**Re: Estrella Substation and Paso Robles Area Reinforcement Project (A.17-01-023) –  
Pacific Gas and Electric Company Comments on Draft Alternatives Screening  
Report**

## Pacific Gas and Electric Company Estrella Substation and Paso Robles Reinforcement Project (A.17-01-023)

### Comments on Specific Alternatives Presented in Alternatives Screening Report

**Figure 1: Proposed Project 70 kV Reroute**

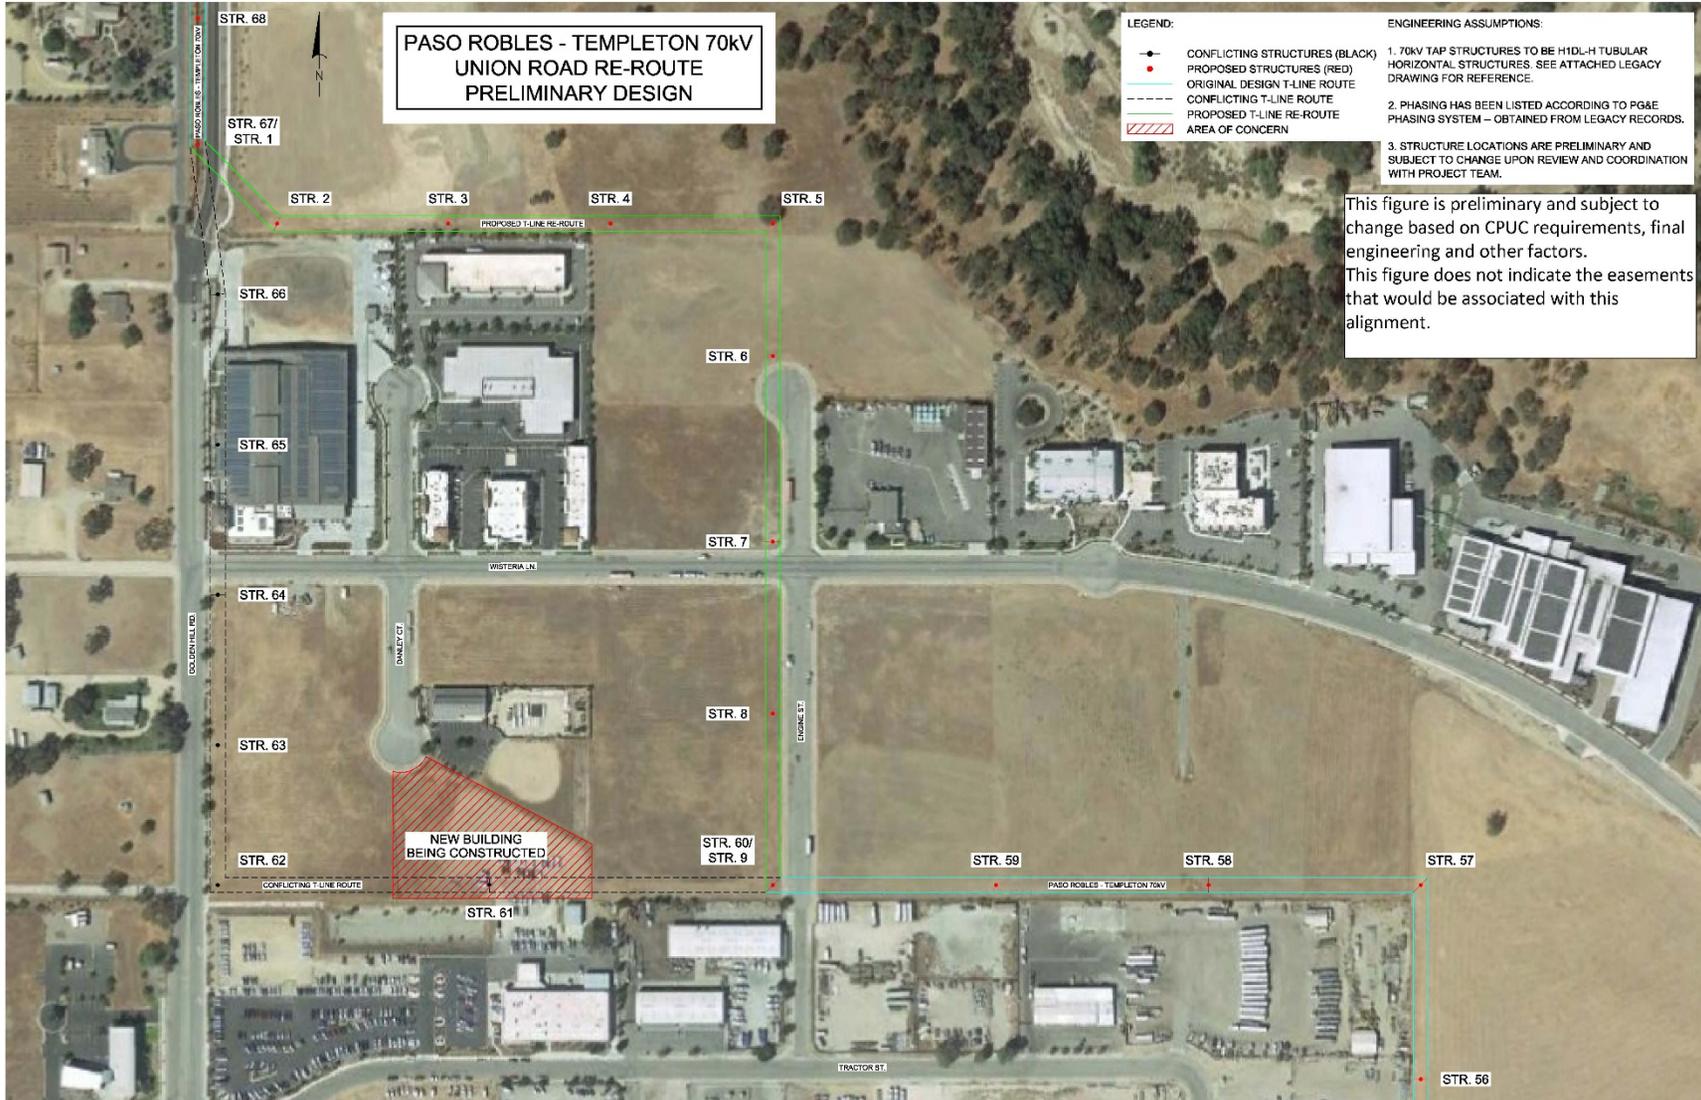
During a recent walkdown of the Proposed Project 70 kV route, we discovered that a portion of our proposed overhead double-circuit transmission line route that would run through the Golden Hill Industrial Park will need to be re-routed to address a new construction project currently underway on Tractor Danley Court Street between Germaine Engine Street Way and Golden Hill Road. We propose to make a minor modification to the proposed overhead routing of the new transmission line as outlined in blue in Figure 1. We note that this slight change to the routing of

the overhead line would place it out of the direct view of the San Antonio Winery tasting room. Also, this new construction project would impact the routing of PLR-3 as shown on Figure 3-6 of the ASR.

**Figure 2: Paso Robles Substation Summer Peak Load (MW) and the Transmission Capability During P1 Contingency (Loss of Paso Robles-Templeton 70 kV Line)**

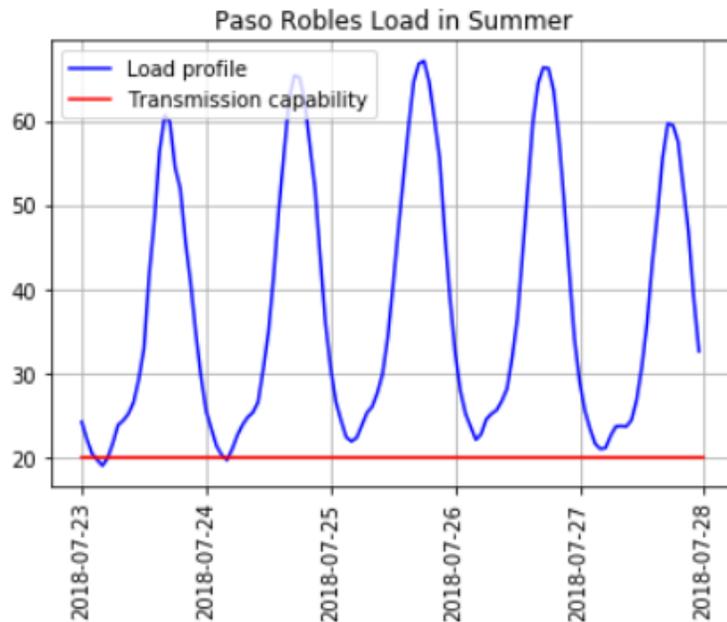
According to load data at Paso Robles Substation, the load is higher than the available transmission capability (under the P1 contingency above) even in the night during the summer peak period (see Figure 2). Meanwhile with the battery alternative, the transmission capacity will not increase but the load will increase in the future. This situation will make charging the BESS infeasible. Following the current operational standard, the system should be operated to secure N-1 outages (P1); i.e., if a P1 contingency were to happen, there should be no violations without system adjustment. In order to meet this standard, the BESS has to discharge once the load is higher than 20 MW to make the system N-1 secured. According to the real-time data

shown in Figure 2, there will be no charging window or not enough charging window in multiple days during the summer peak period after discharge if the battery energy requirement is for 24-hours only.
